**RE: PORTER DRYWALL -- 655 RIVERSIDE STREET
AMENDED SITE PLAN**

RE: PORTER DRYWALL MINOR SITE PLAN REVIEW, 655 RIVERSIDE STREET

RE: Porter Drywall-655 Riverside Street-Amended Site Plan
CBL: 311-A-6001
APP #: 2002-0249

Data for 285-01; Porter Drywall, Post, 2 yr
 TYPE III 24-HOUR RAINFALL= 3.00 IN

PORTER DRYWALL
DRAINAGE IMPROVEMENTS
WITH INFILTRATION TRENCH
 DATE: 4/13/01
 SCALE: 1" = 20'

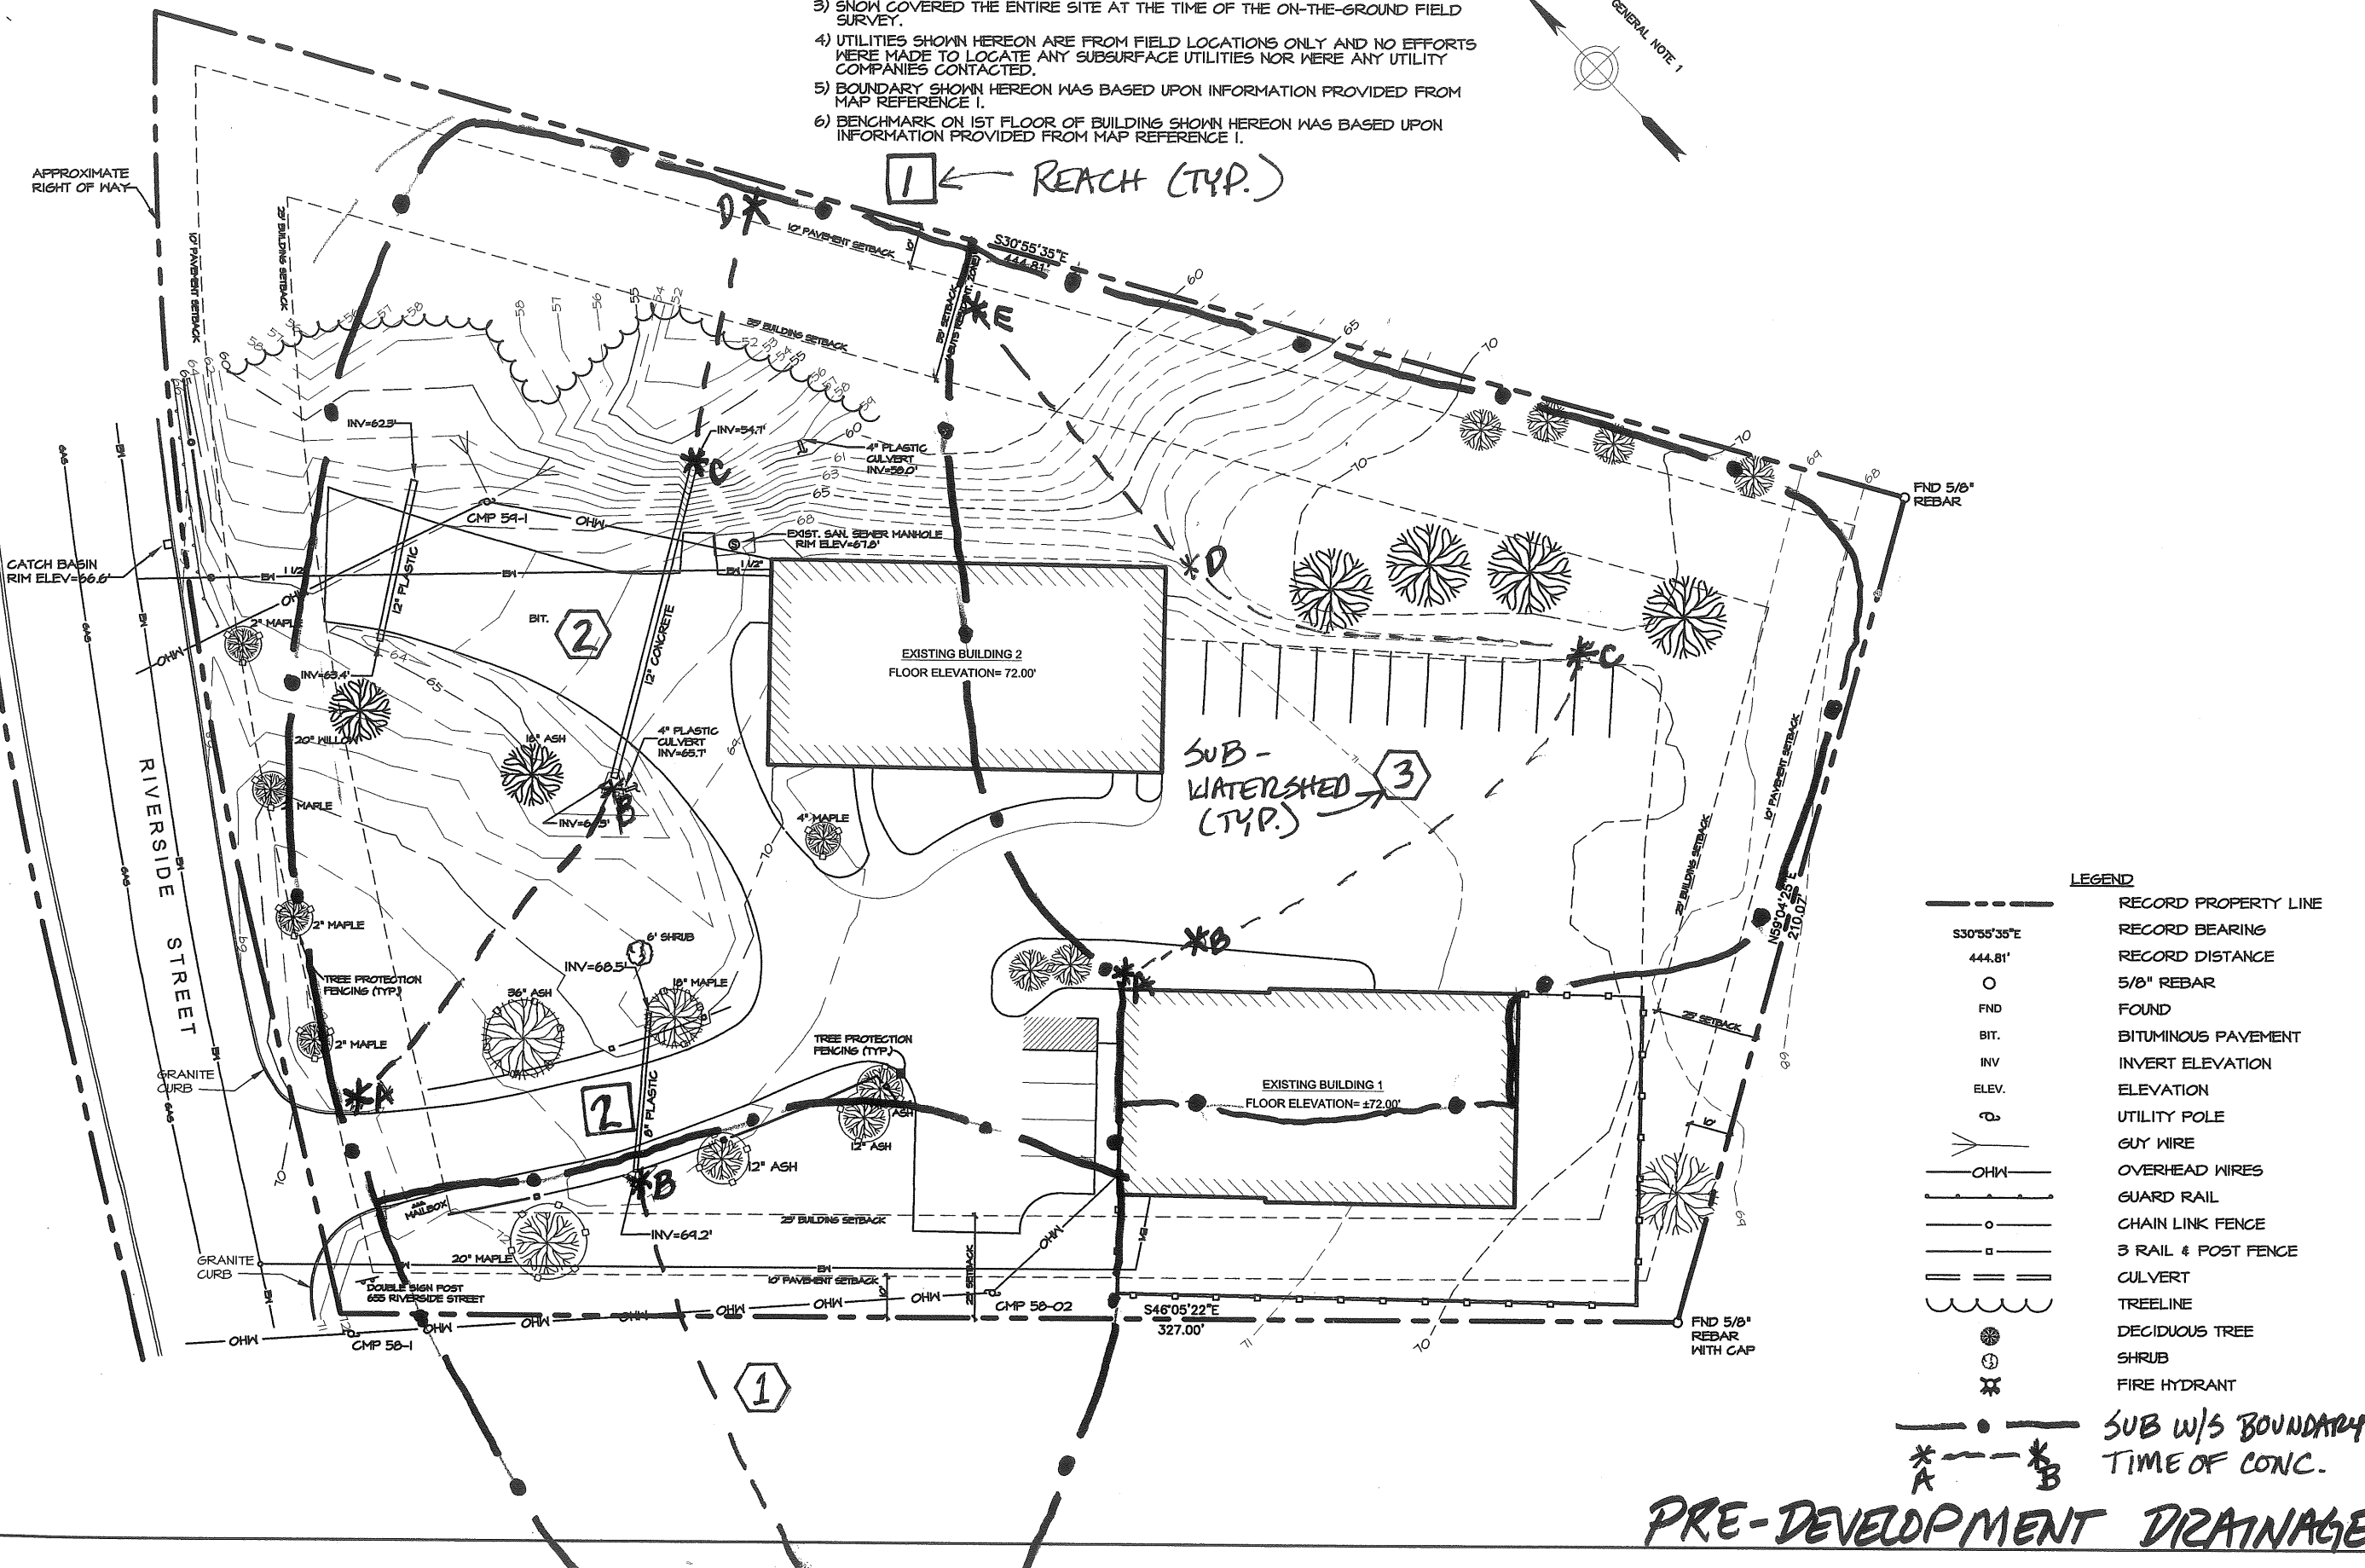
1. The applicant will submit an acceptable detail for the proposed infiltration trench prior to permit issuance.

1. **Construction Entrance:** The applicant will not install a temporary construction entrance for this project. Revised drawing L-3, revision date April 13, 2001, reflects the absence of the construction entrance.
2. **Wall-Pack Units:** Attached are new cut sheets for the wall-pack units. These 100w metal-halide units by McGraw-Edison do not have a visible light source. Also, attached is revised SK-L5 showing the revised photometrics for this unit.
3. **Stormwater:** Bill Walsh P.E. from Mohr & Seredin spoke with Steve Bushey this morning about this project. Per that discussion, an infiltration trench drain will be added to the proposed swale at the northern edge of the parking area. Attached is a sheet entitled "Drainage Improvement with Infiltration Trench," dated April 13, 2001, showing the location and detail of the proposed infiltration trench.
